**RE: Subgrade Inspection for Lot # 130 Pergola Park– 1063 SW Corinthian Ln
Lee's Summit, MO 64081 – Permit # 2025-3755**

On September 25, 2025, a special inspection was performed by Everstead at the above referenced property. The purpose of this inspection was to determine structural adequacy of the existing soil for construction of concrete foundation.

SPREAD FOOTING
DETAIL
N.T.S.

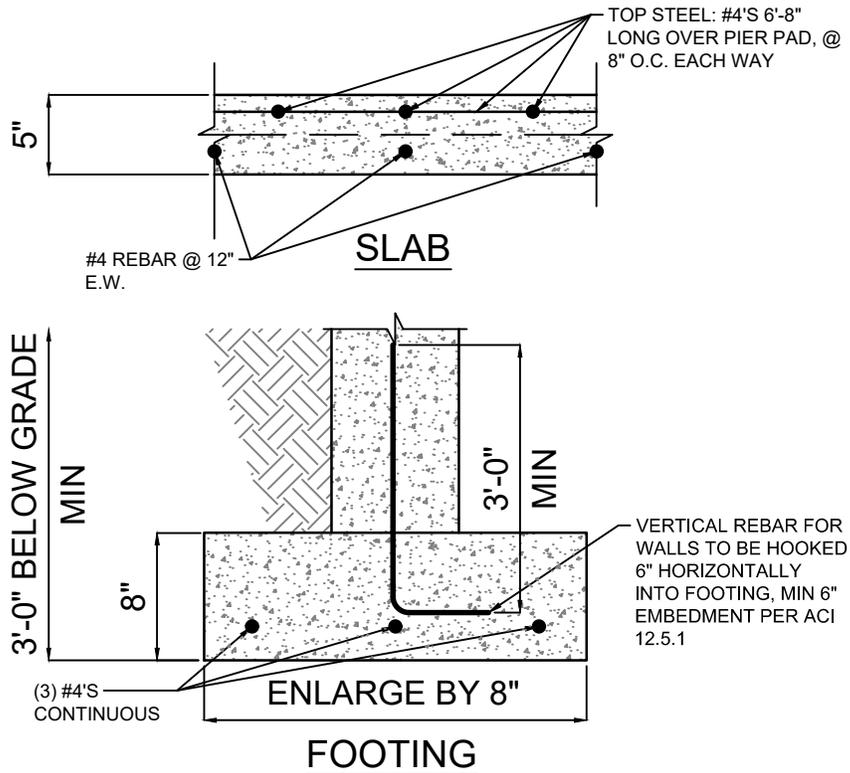
- The soils observed at footing elevation were silty clay; medium brown; medium plasticity and damp.
- Probes and penetrometer readings indicated that the soils on the front left quarter of the lot do not have sufficient bearing capacity for the loads applied by foundation per permit plans.

- Everstead recommends that the footings on the front left quarter of the lot be enlarged by 4" each way (i.e. existing 16"x8" footing shall be enlarged to 24"x8", etc.) with three (3) #4 rebar continuous (see attached specifications).
- Basement and garage pier pads on the front left quarter of the lot shall be enlarged a minimum of 6" each way (i.e. existing 30"x30" shall be enlarged to 36"x36", etc.) (see attached specifications).

NOTE: PIER PAD SCHEDULE HAS BEEN INCREASED WITH THE USE OF THIS SPREAD FOOTING DETAIL. TABLE IS BASED ON EVERSTEAD SPECIFICATION REFERENCES AND MAY NOT DIRECTLY TRANSLATE TO PLANS ENGINEERED BY OTHER FIRMS. REFER TO SITE SPECIFIC DESIGN FOR PIER PAD SIZES.
